ADDENDUM NO. 1

City of Spring Valley, MN
Wastewater Treatment Facility Improvements
Bid Date: October 27, 2026
Bid Time: 2:00 PM
BMI Project No. 0M2.131536

1 POWER & SYSTEMS PLAN BLOWER BUILDING UPPER LEVEL

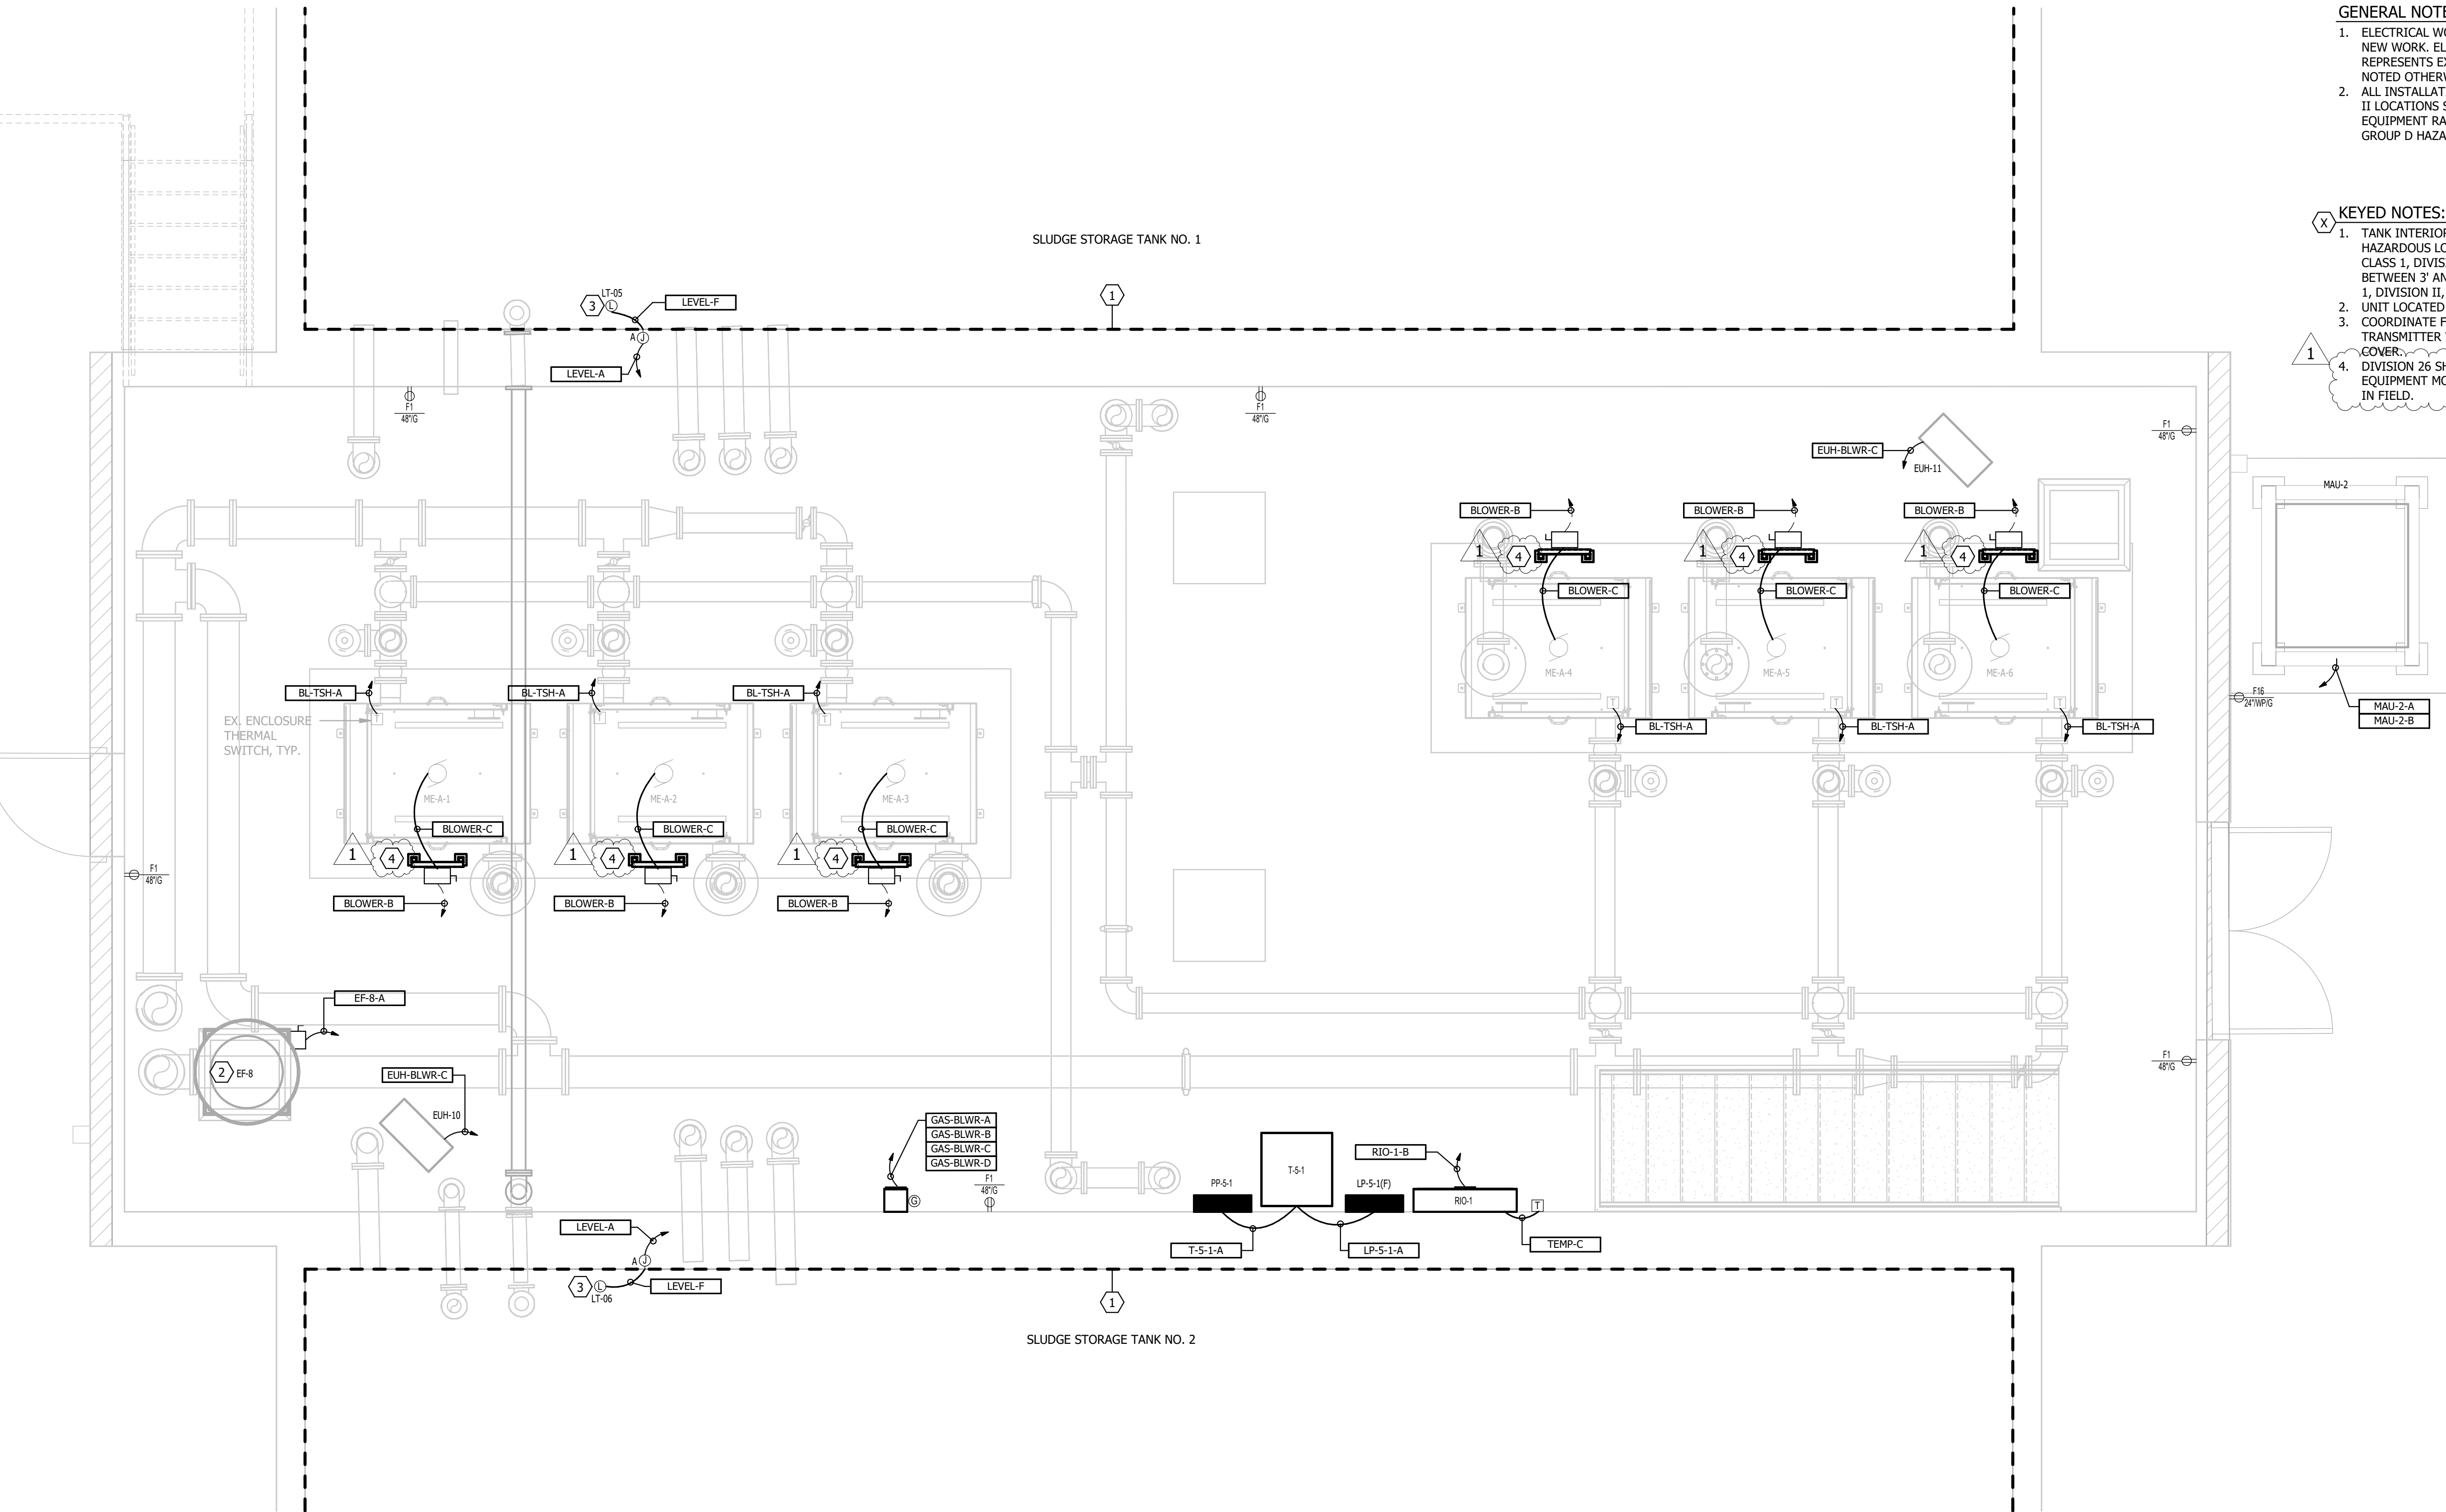
- b. Revise (2) Exit signs to EX1 type.
- Item II.1.14 Sheet 7.21 – Power & Systems Plan – Blower Building Upper Level**
- a. Replace Sheet 7.21 Rev 0 09/29/2026 with attached Sheet 7.21 Rev 1 10/08/2026.

- b. Add keynote #4. Division 26 shall provide galvanized Unistrut support for equipment mounting. Coordinate exact mounting location in field.
 - c. Place keynote #4 on floor plan near Unistrut for each blower.

1 ELECTRICAL PLAN CLARIFIERS

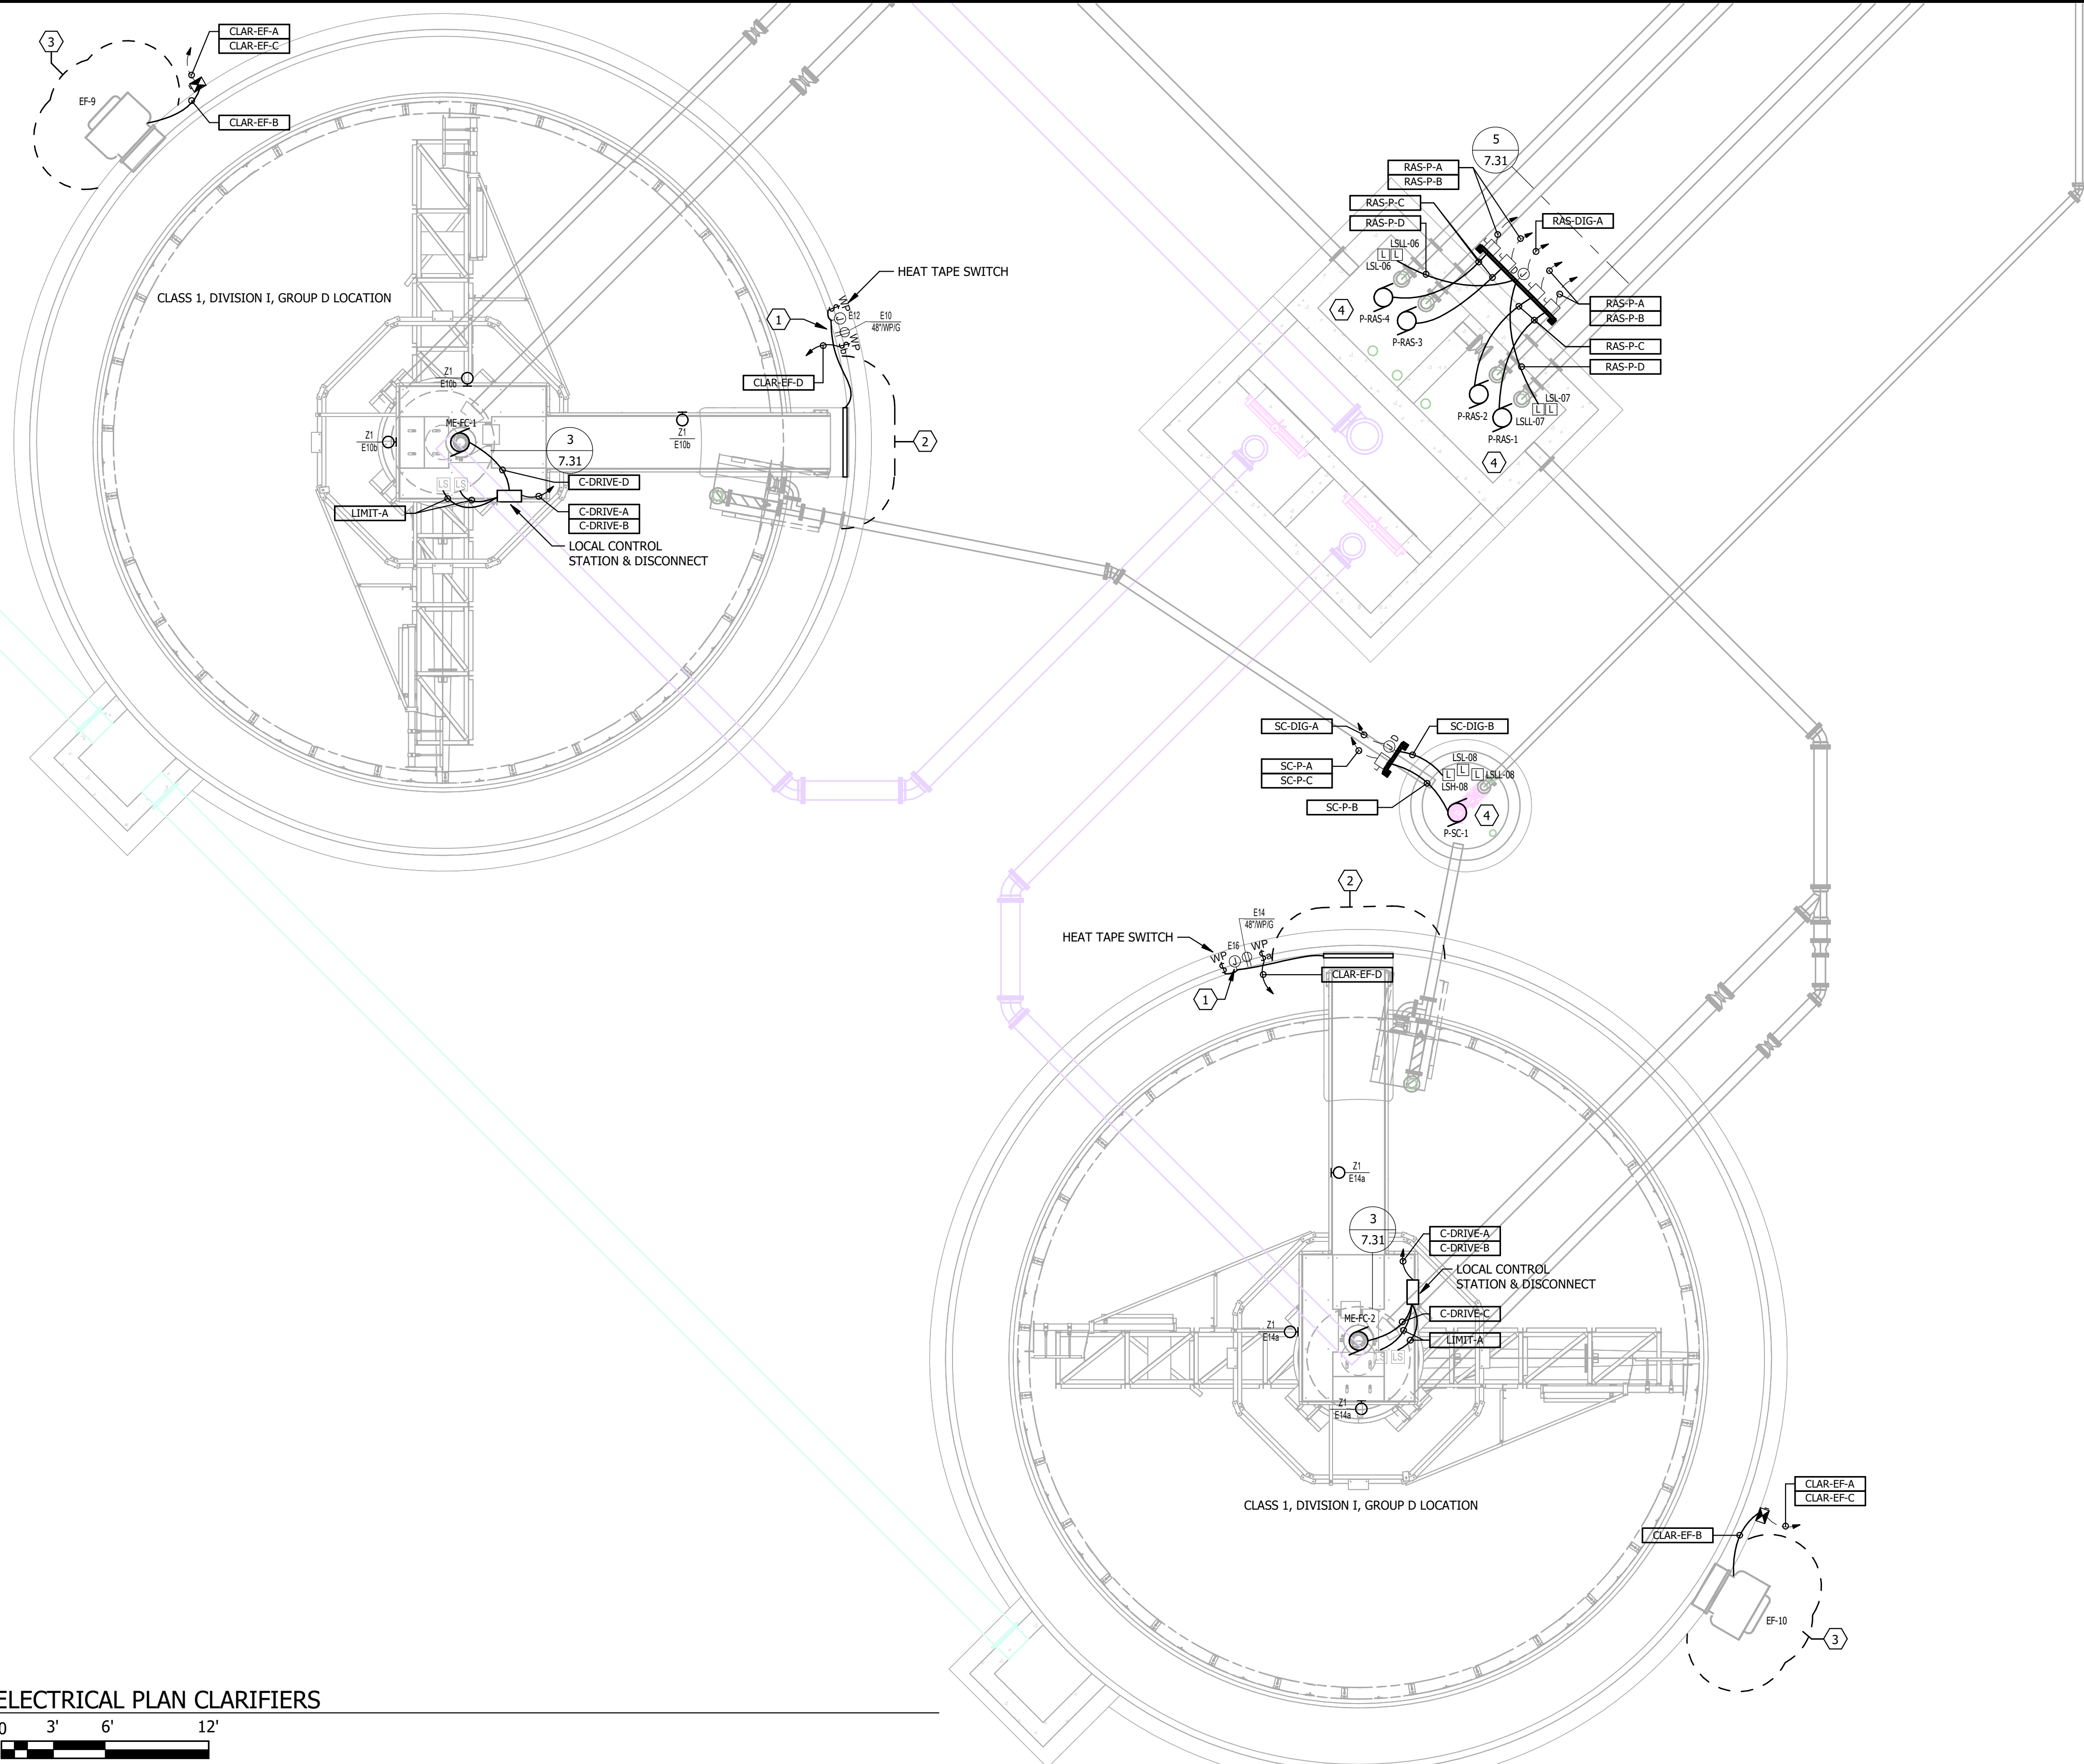
- b. Rotate two light fixtures.
 - c. Revise (1) Exit sign to EX1 type.
- Item II.1.16 Sheet 7.23 – Electrical Plan - Clarifiers**
- a. Replace Sheet 7.23 Rev 0 09/29/2026 with attached Sheet 7.23 Rev 1 10/08/2026.

- b. Revise keynote #1.
- Item II.1.17 Sheet 7.25 – Electrical Plan Main Lift Station Details**
- a. Replace Sheet 7.25 Rev 0 09/29/2026 with attached Sheet 7.25 Rev 1 10/08/2026.
